MANDATORY SERVICE BULLETIN

NUMBER: SB-016
REVISION: B
DATE: 06/01/2010

SUBJECT: FLAP SYSTEM; FLAP DRIVE ACTUATOR REPLACEMENT

Flap Drive Actuator Replacement

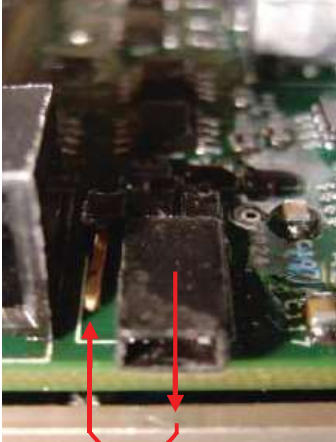
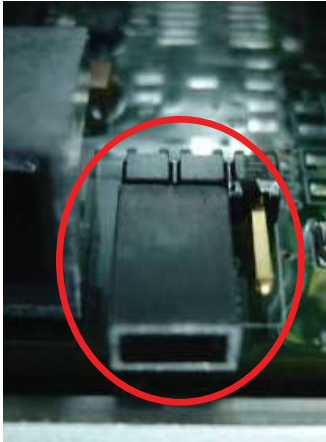
3	<p>Turn the Aircraft Master Switch ON and move the flap lever to 10°. Turn the Aircraft Master Switch OFF.</p>	
4	<p>Move the Jumper located within the box to the rigging position as shown in Figure 2.</p> <p>NOTE: Figure 1 shows the jumper in the operating position, and Figure 2 shows the jumper in the rigging position.</p> <p>NOTE: The jumper can be removed and replaced in its proper position easily with a pair of needle nosed pliers.</p>	  <p>Figure 1: Operating Position</p> <p>Figure 2: Rigging Position</p>
5	<p>Turn the Aircraft Master Switch ON. The flaps will automatically move to 30°. After the flaps have stopped moving to 30°, turn the Aircraft Master Switch OFF.</p>
